U.S. NUCLEAR REGULATORY COMMISSION

Report No. 40-3392/90004

Facility Name: Metropolis Works

Inspection on June 18-20, 1990 (Report No. 40-3392/90004(DRSS))

Figure 1., UF₆ CYLINDER SAMPLING SYSTEM;
SHOWING NO. 1 + NO. 2 SAMPLE LINES

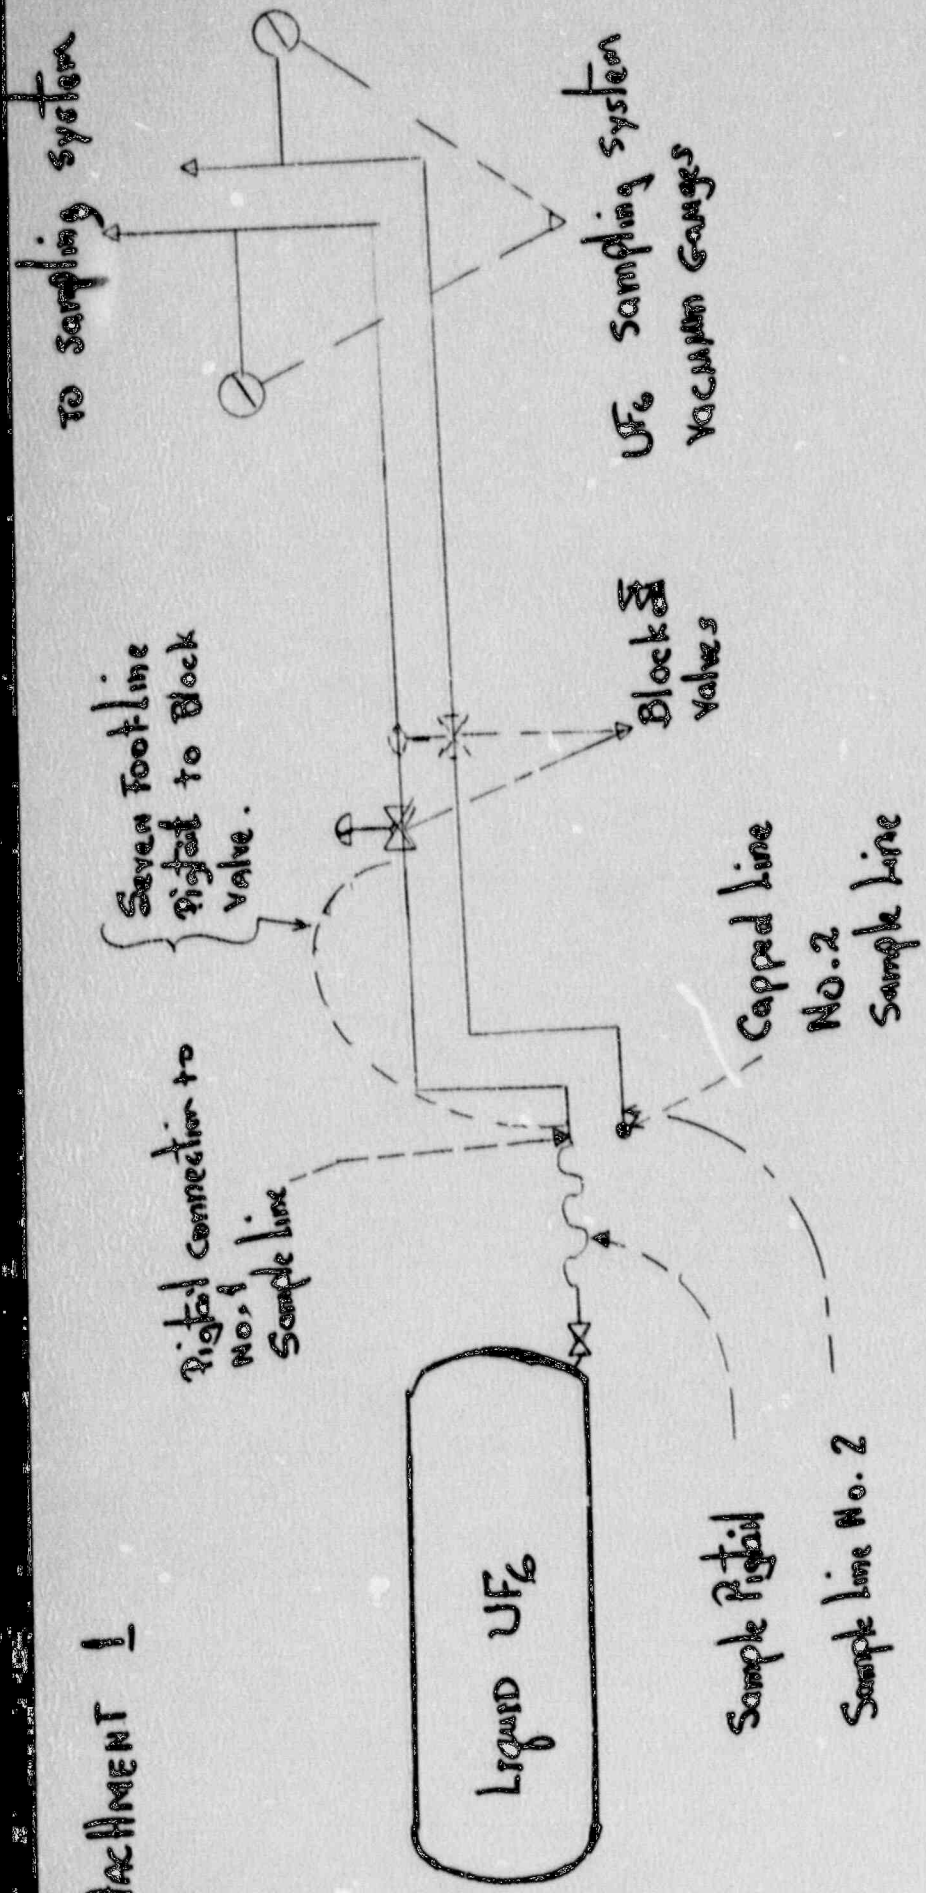
- The No. 1 sample line at the No. 1 product fill-station had not been used in 6 weeks. Residual UF_6 probably coated the line between the sample line block valve and the pigtail connection (7 foot line). This is plausible since the block valve was found to be leaking. A redundant seal in the valve (by design) prevented the leakage of UF_6 to the atmosphere. When liquid UF_6 is admitted to the sample line from a cylinder located in either one of the four product filling stations, it is possible that liquid UF_6 makes contact with the four block valves located in the No. 1 sample line. Under these conditions UF_6 seepage could occur between a leaking valve and the capped end of the line (7 foot length of line where the pigtail is connected). If cold spots were present some freeze out of UF_6 in the line would also occur.

- e. Review the possibility of shortening the distance between the block valve and the capped end of the sample line; install a vacuum gauge for this portion of the system.

- f. Review the maintenance/preventive maintenance program on the sampling line and sampling unit to assure gauges, valves, connections and heat trace requirements are operable.

- g. Improve the vacuum (high exhaust) in the local sampling lines by installing an auxiliary cold trap arrangement that would eliminate the use of the dust collector for this purpose. Hence, evacuation of small emissions of UF_6 using a vacuum wand (elephant trunk, etc.)

would traverse to a high exhaust cold trap. If this is not a feasible arrangement, what are the safety and/or operational concerns that favor the use of the dust collector?
